**BEFORE THE PUBLIC UTILITY COMMISSION  
OF OREGON  
PCN-2**

**INTERVENOR TESTIMONY OF DAVID MAST**

January 14, 2019

## David Mast – Intervenor Testimony - Issues List

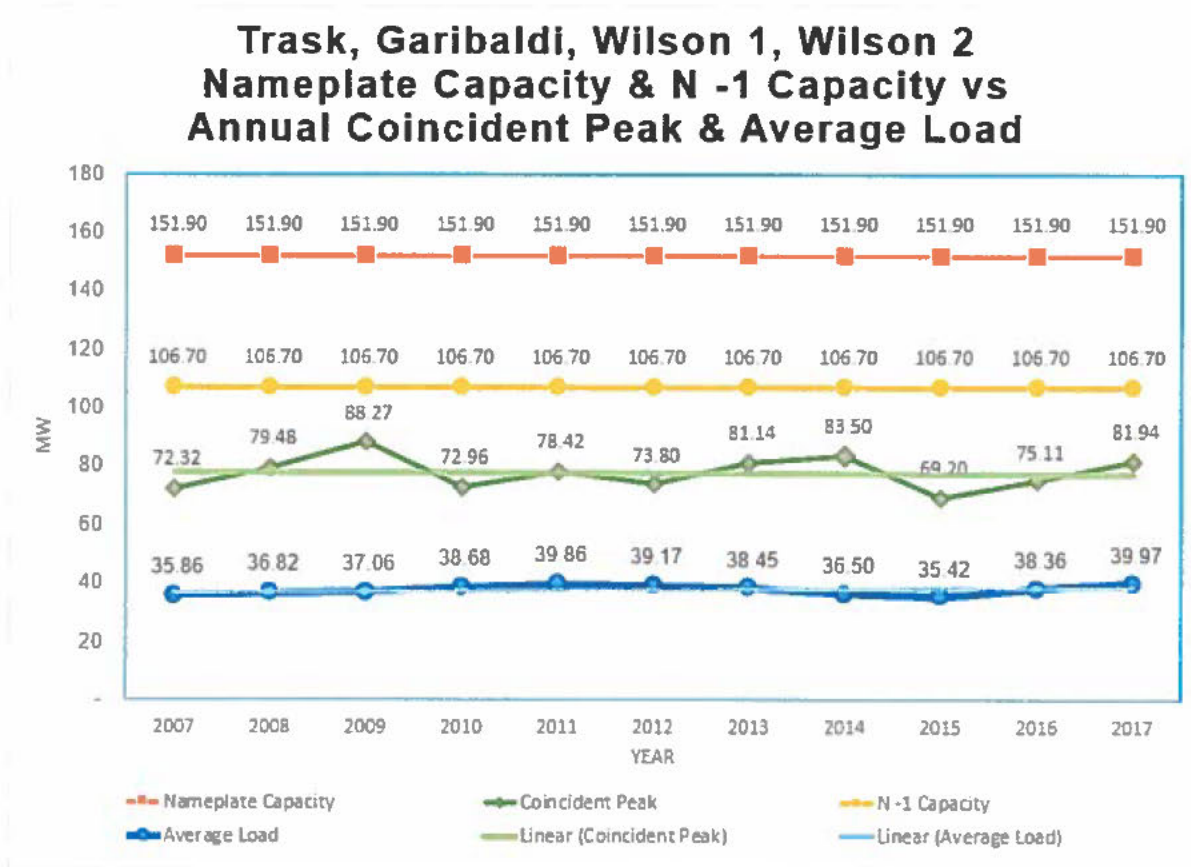
Garibaldi substation loads for every hour of every day. I summarized the data from the TPUD Exhibit and developed the chart shown below.

The total capacity of the 4 substations that feed the central valley and Oceanside – Netarts is 151.9 MW. The N -1 capacity is 106.7 MW. The maximum peak which occurred in 2009 was only 58% of the capacity of the 4 substations and only 83% of the substations’ N -1 capacity. The average load on the substations was 37.83 MW. That is only 24.9% of the substations’ total capacity and only 35.4% of their N -1 capacity.

From the data, I see that TPUD is able to adequately provide service to existing and new loads without needing to build a transmission and substation to Oceanside – Netarts.

KC Fagen's Chart – Wilson 1 & 2 Growth

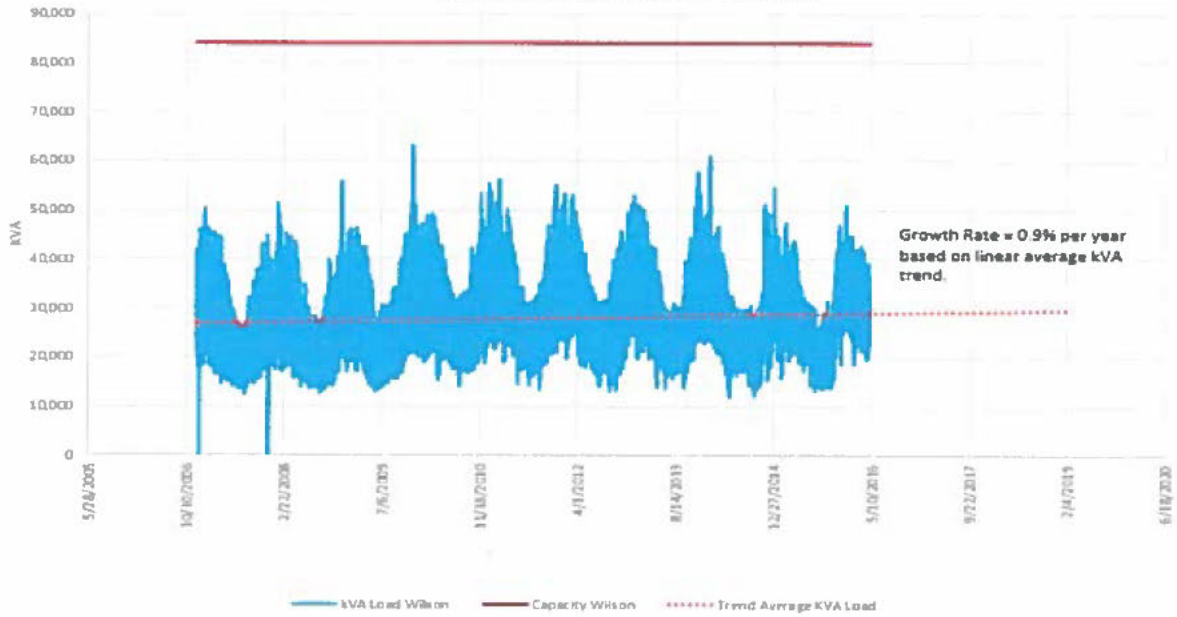
In his follow up testimony, KC Fagen reports a growth of 0.9259% per year for Wilson 1 & 2<sup>6</sup>. KC Fagen's 0.9259% growth for Wilson T1 & T2 is based on the load trends of the Wilson River 1 & 2 from 2006 – 2016. His analysis has the same major error and is also significantly distorted upward because it also ignores the fact that in 2009 the TCCA boiler came on line. His chart gives a false assumption about the future growth of Wilson River 1 & 2.

I took TPUD's data that KC Fagen used for his trend line and developed a trend line from 2009 – 2016 to eliminate the load distortion that occurred when the boiler came on line in 2009. The trend line for 2009 – 2016 based on TPUD's data shows that growth on Wilson River 1 & 2 was flat, showing that all the growth KC Fagen is talking about, in fact, came from the TCCA boiler going on line. (Data is from Staff DR 19 a b c e)

Same TPUD data as KC Fagen's just charted from 2009 - 2016

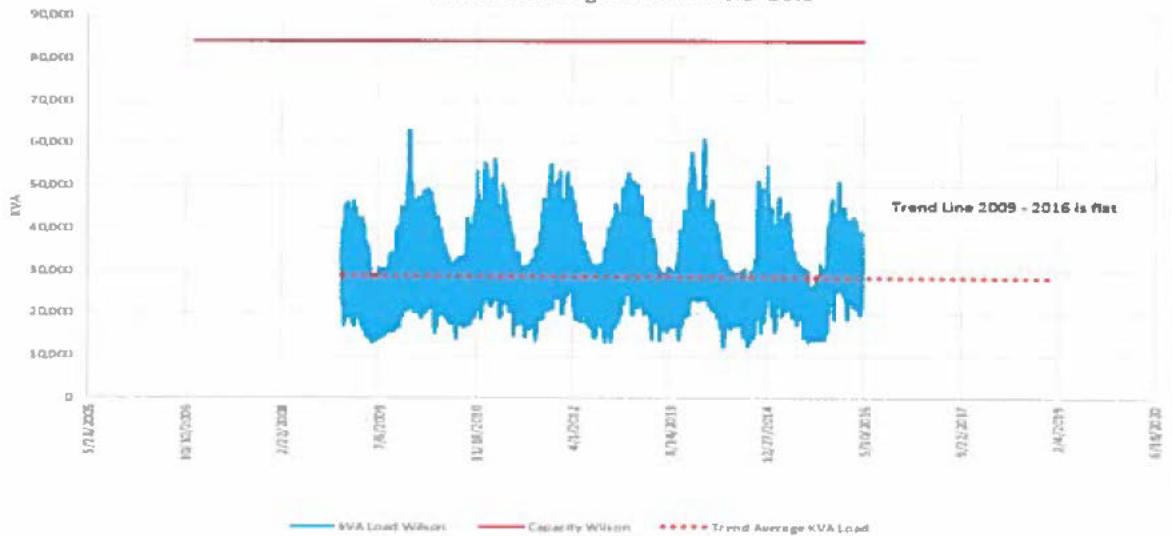
KC Fagen's 0.9259% load growth number is a significantly distorted number. The 2012 official forecast was for a total system growth of 0.45%. Actual growth from 2012 – 2017 in the total system was below 0.45%. Growth of the 4 substations that serve the central valley is only 0.20%. Wilson T1 & T2 show no growth in 2009 – 2016. The projected growth in the 2019 Budget is only 0.5%<sup>7</sup>. Nowhere do any of the growth numbers come close to the 0.9259% he is using to justify the need for the transmission line and substation.

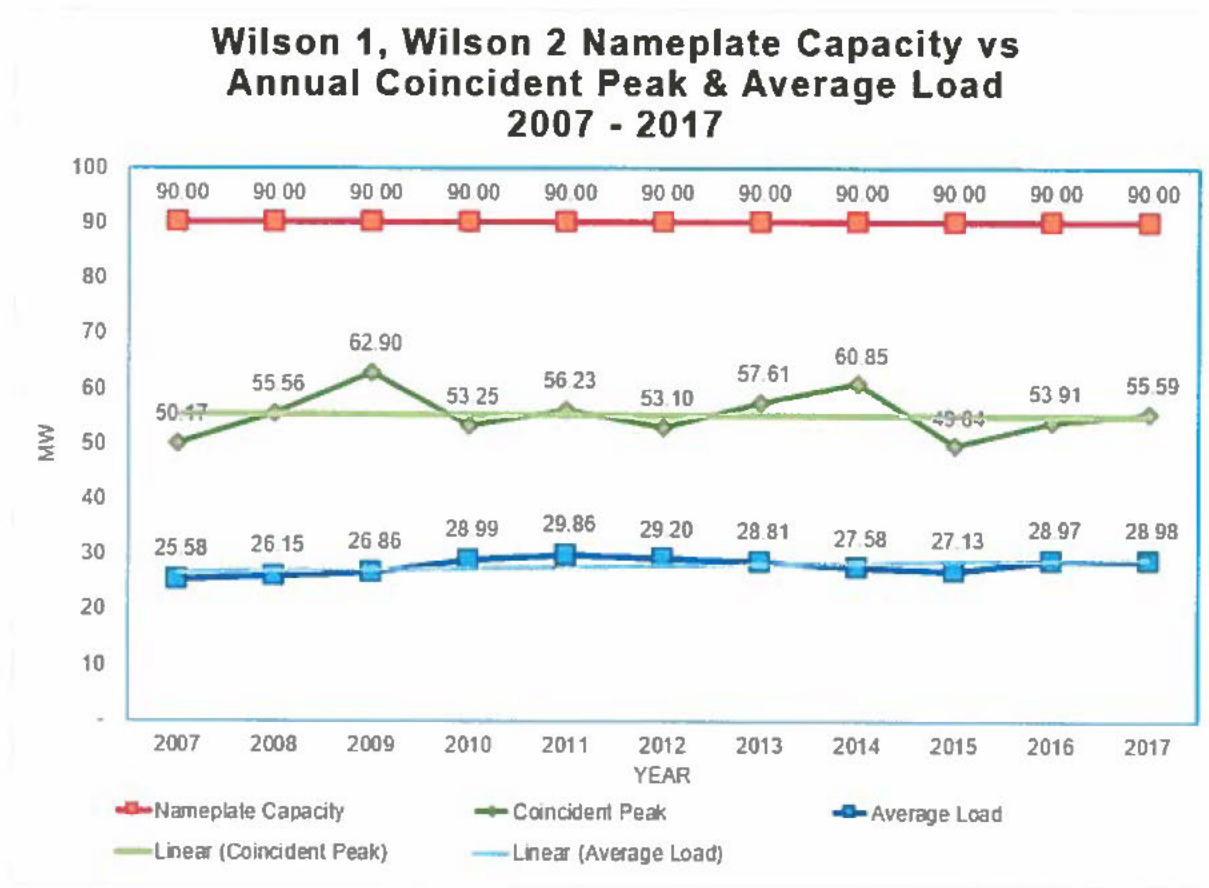
Below, I have graphed the average loads and coincident peaks for Wilson 1 & 2. This data is also from TPUD Exhibit 403 W1-W2 load. Notice the growth in the average load between 2008 and 2009 because of the addition of the TCCA boiler. You can see that the maximum load Wilson 1 & 2 is only 70% of capacity and average load is only 33% of capacity.

**Wilson 1, Wilson 2 Nameplate Capacity vs Annual Coincident Peak and Average Load 2010 - 2017**

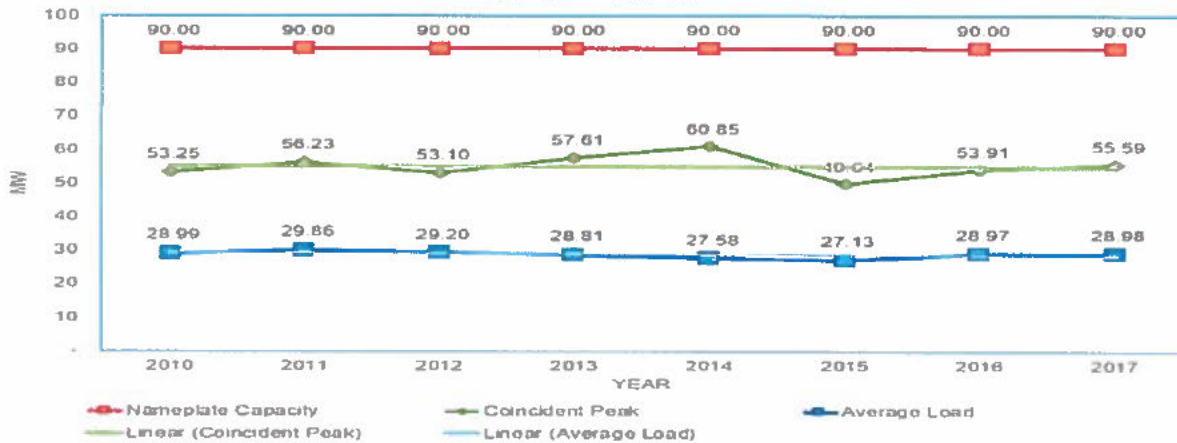
Below, I have graphed the average loads and coincident peaks for Wilson 1 & 2 starting in 2010 after the 4 MW TCCA electric boiler went on line. You can see that the coincident peaks and average loads of the Wilson 1 & 2 after 2009 are flat.

**Trask Substation Nameplate Capacity vs Annual Coincident Peak & Average Load**

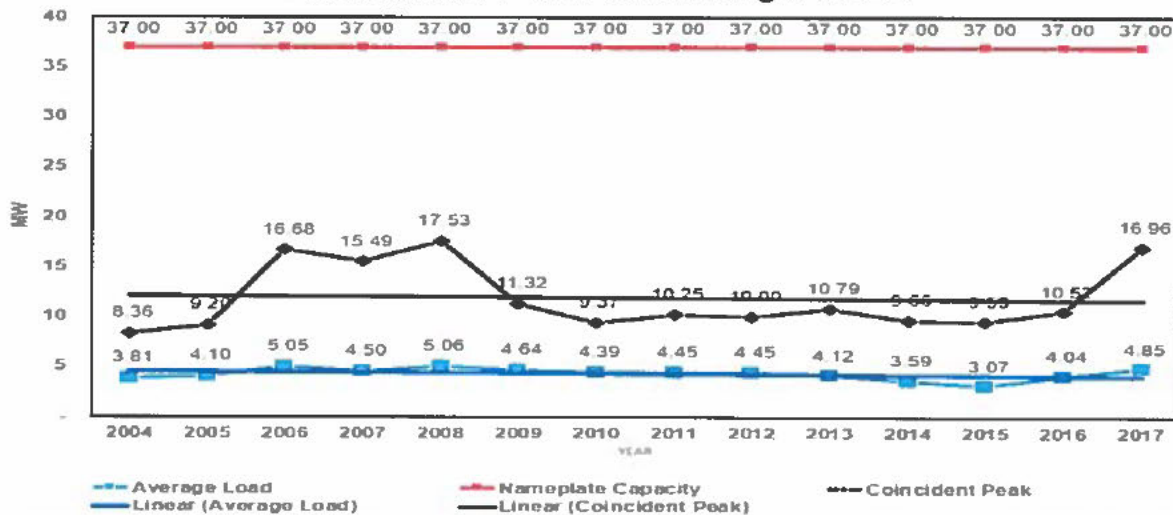
The Trask substation is only loaded at 12% of capacity and the highest coincident peak was only 47% of capacity. Moving feeder 51 to the Trask would relieve 5 – 12 MW from the Wilson River T1 & T2 and it would put the Task at a more efficient level. The \$16 transmission line/substation is planned to take load off the Wilson Rivers. Moving feeder 51 to the Trask accomplishes the same thing for a lot less cost.
